Proposal submitted by Irisbus for the testing of power-operated ramps

Proposed new text is marked in **bold** and deleted text strikethrough

Annex 8, paragraph 3.11.4.3.3. amend to read:

Figure 1

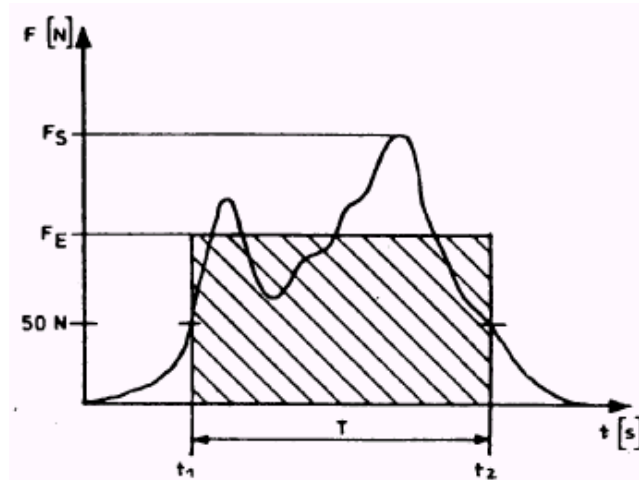
The closing of a power-operated door **and the extension of a power-operated ramp are** ~~is a~~ dynamic ~~process~~ **processes**. When a moving door **or ramp** hits an obstacle, the result is a dynamic reaction force, the history of which (in time) depends on several factors (e.g. mass of the door **or ramp**, acceleration, dimensions).

- 2.1. Closing **or reactive** force $F(t)$ is a time function, measured at the outer edge of the door **or ramp** (see paragraph 3.2. below).
- 2.2. Peak force F_S is the maximum value of the closing **or reactive** force.
- 2.3. Effective force F_E is the average value of the closing **or reactive** force related to the pulse duration:

t_1 = threshold of sensitivity, where the closing **or reactive** force exceeds 50 N.

t_2 = fade-away threshold, where the closing **or reactive** force becomes less than 50 N.
